An
Bord
Pleanála

Observation on a Large-scale residential development Appeal: Form

LH04.322734

Description of Development: Large Scale Residential Development (LRD)

(Section 4 Transportation Network p62 Carrigaline TPREP, amended to include the site location outlined in red)

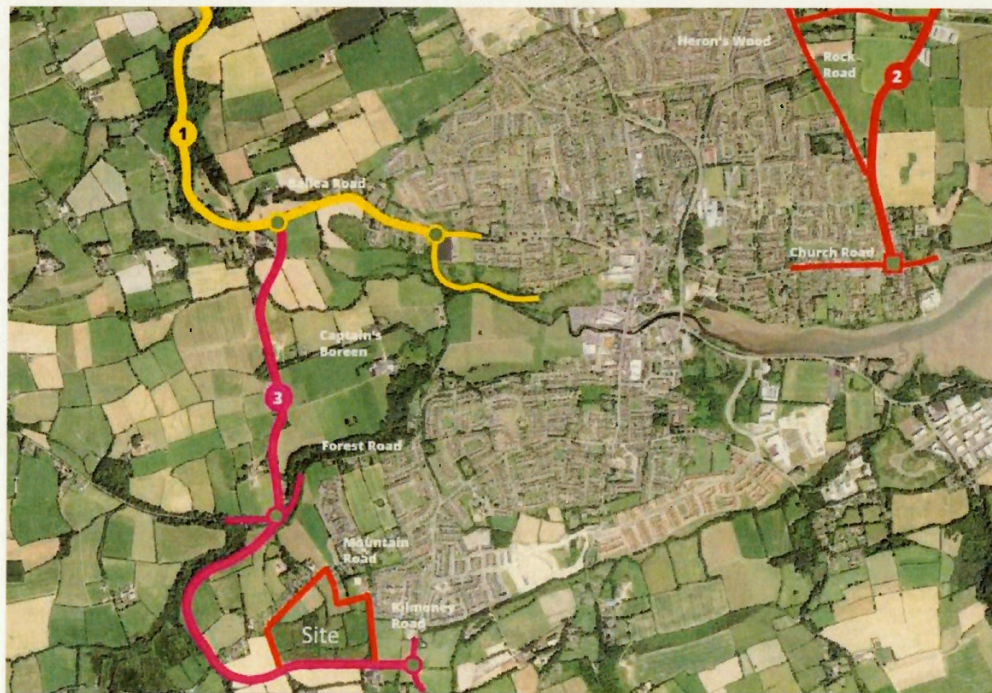
The current proposal as it stands without an alternative access road is a **material contravention** of the County Development Plan. A way to resolve this problem would be to provide the main development access to the south of the site and directly onto the R611. This alternative that would tie in with the TPREP, and consequently the County Development Plan, and could form part of the proposed Southern Outer Distributor Road, which is planned to run to the south of the proposed development (See below extract from the Carrigaline TPREP).

It would also remove the construction traffic from the Mountain Road and allow for a viable alternative access to the existing dwellings, should road closures be necessary. It

would allow for permanent alternative access to the site and allow the Mountain Road to be developed as part of the Primary Pedestrian and Cycle Network, which is in line with the recommendations of the Carrigaline TPREP. It should be noted that the TPREP specifically states that it is not intended to connect the Mountain Road to the Southern Distributor Road as it *'not capable of carrying any additional traffic'*.
